**ITEM #8 - PRELIMINARY PLAT
NEWELL PARK EAST WILSON REPLAT**

KPB File No.	2026-61
Plat Committee Meeting:	July 20, 2026
Applicant / Owner:	Joseph Wilson Jr and Patricia Wilson / Chugiak, Ak
Surveyor:	Christopher Mullikin / Mullikin Surveys
General Location:	Fritz Creek

STAFF REPORT

WILSON REPLAT NEWELL PARK EAST LOT 4 SUBDIVISION

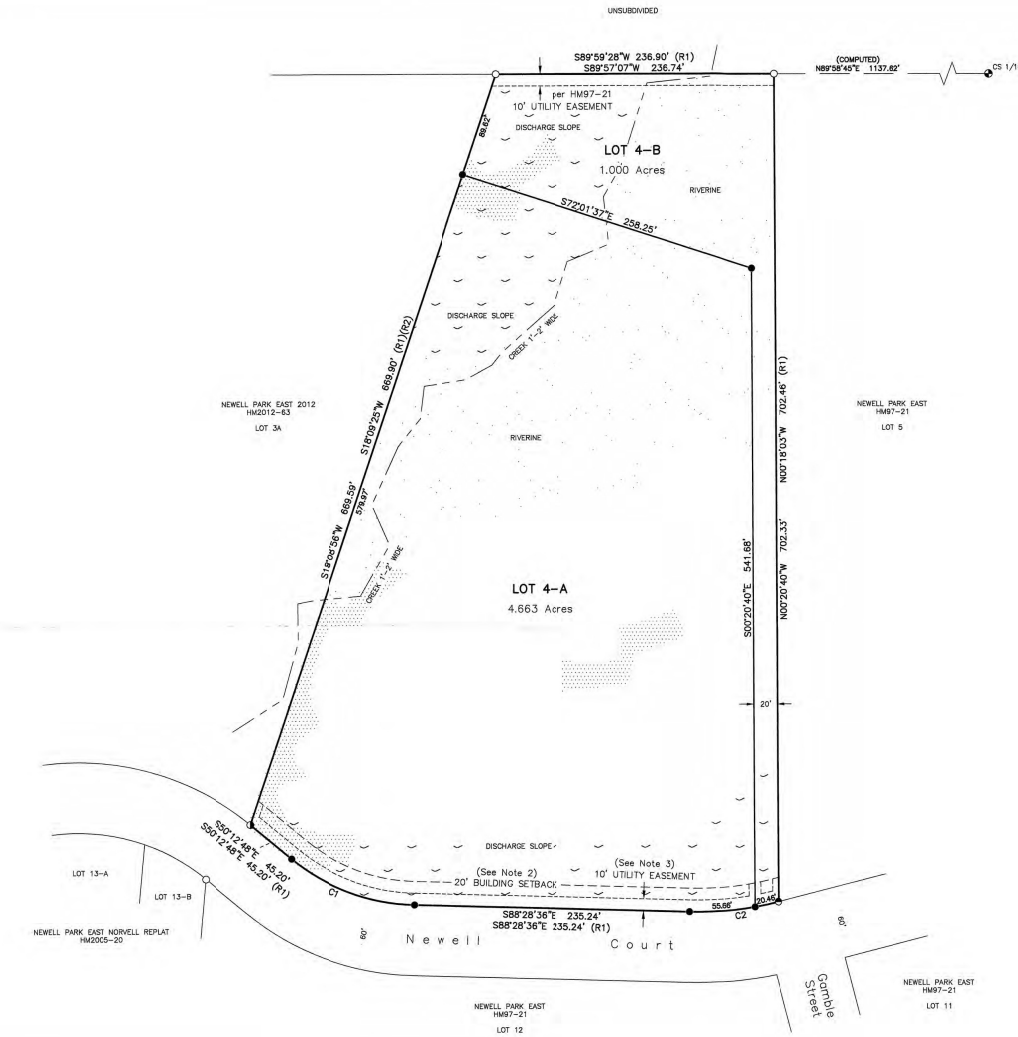
Plat note 5 indicates the 20' utility easement along the interior lines were vacated by PC Resolution 2012-48. This is incorrect and plat note 5 should be removed. The 20' utility easement centered along all interior lot lines needs carried forward to this plat and shown on the drawing and included in the plat notes per KPB Code.

Under the Certificate of Ownership and Dedication, add the house number for both signer's address.

In the Plat Approval, change the date to July 20,

Remover Plat note 5, PC Resolution 2012-48 was for Lots 1 & 2 only.

Complete plat note 6 with the exception granted by this meeting.

- Add a plat note in reference to the covenants, conditions and restrictions.
- Carry forward plat note 5 from the parent plat

Add the KPB File No of 2026-061 to drawing
Add house number to address

- C. The location, width, and name of existing or platted streets and public ways, railroad rights-of-way, and other important features such as section lines or political subdivisions or municipal corporation boundaries abutting the subdivision;
Staff recommendation:
Add the ROW width to Gamble St
- F. The location, width and name of existing and platted streets and public ways, railroad rights-of-way, easements, and travel ways existing and proposed, within the subdivision;
Staff recommendation:
Carry forward plat note 5 from parent plat.
- N. Apparent encroachments, with a statement indicating how the encroachments will be resolved prior to final plat approval;
Staff recommendation:
Sent separate drawing with possible encroachment. Is an eve overhang. Not considered substantial issue as is above ground level approximately 9 feet

POTENTIAL ENCROACHMENT

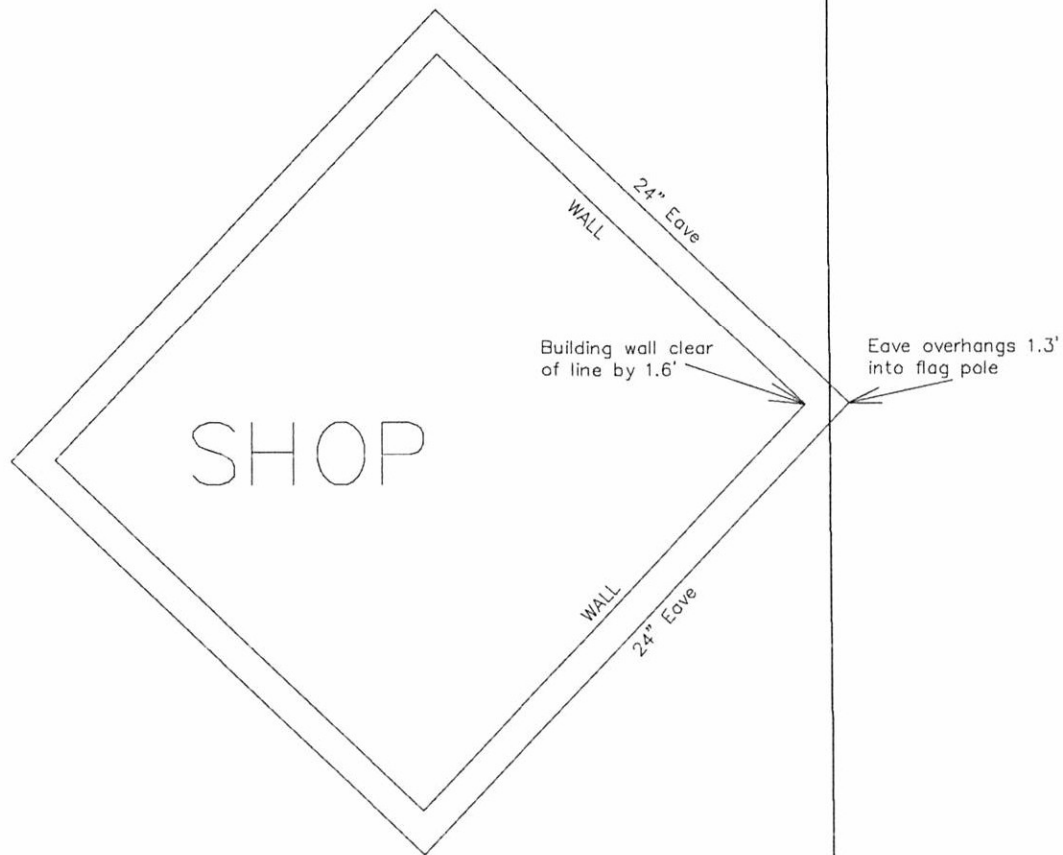
There are structures located on the property when divided will be located on Lot 4-A. with the proposed flag lot division, the surveyor has noted a structure close to the line. A shop structure is close that the eve of the building is over the line 1.3 feet. This overhang of the structure is most likely about 8 – 9 feet about ground surface and should not be an issue. The surveyor shows the wall and foundation of the building to be 1.6 feet back from the division line, making the wall not an issue. **Staff recommends** the Plat Committee concur this is not an issue to be concerned with and no exception or recommendation is needed, but no further expansion of the structure should be done.
